To: Frank Mazzotta Re: 1000 Elgin Mills Road East.

We have reviewed the *Planning Justification Amendment* prepared by KLM Planning partners Inc; dated June 8, 2020.

930 Elgin Mills Road East Town of Richmond Hill, ON

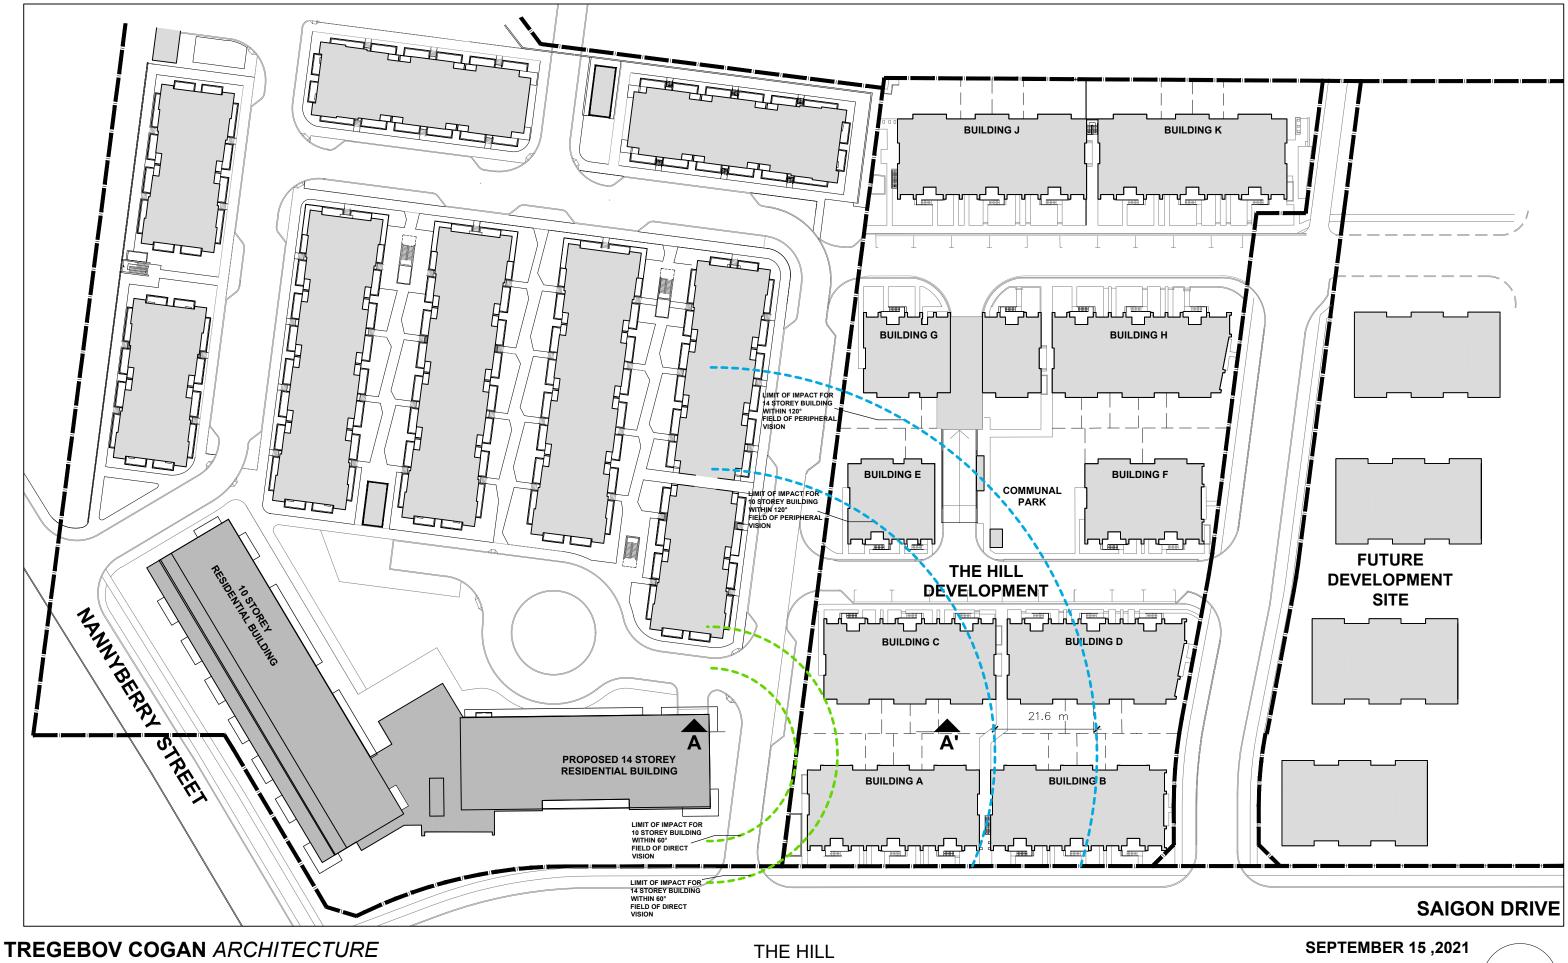
The diagrams also illustrate that the additional height will impact sky exposure from the rear yards when looking upwards. Using a 60° field of direct vision, the easterly rear yards were not impacted by the approved 10 storey building. The proposed 14 storey building penetrates into the field of direct vision. Using a 120° field of peripheral vision¹ the incursion into field of peripheral vision expands by 26m from the rear yards of building 'A' and 'C' into the rear yards of building 'B' and 'D' as well as the communal park.

930 Elgin Mills Road East Town of Richmond Hill, ON PROPOSED 14 STOREY WEST ELEVATION

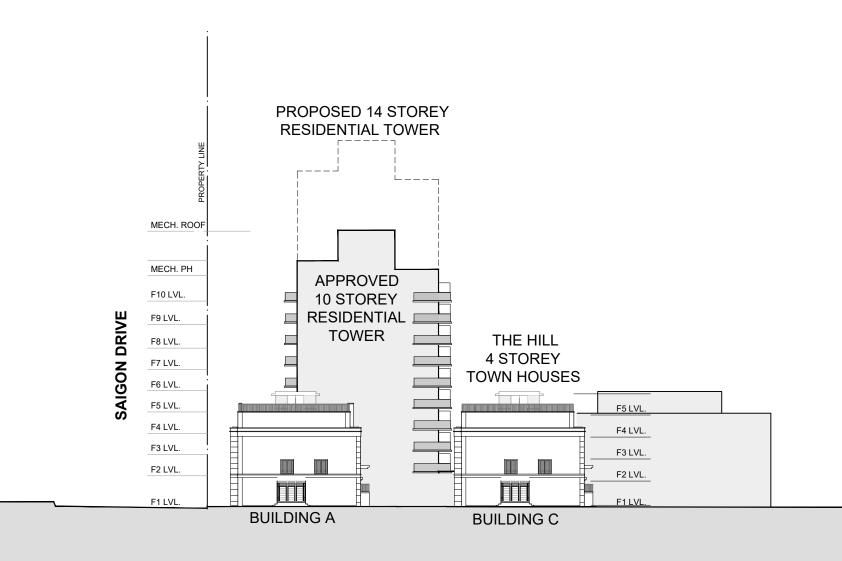
The elevation and section diagrams demonstrate that the proposal lacks an appropriate transition in scale between the 14 storey building and the 4 storey town house dwelling units. There is only 22m separating the two building types. There is no gradual transition in scale, rather an abrupt increase in massing and height.
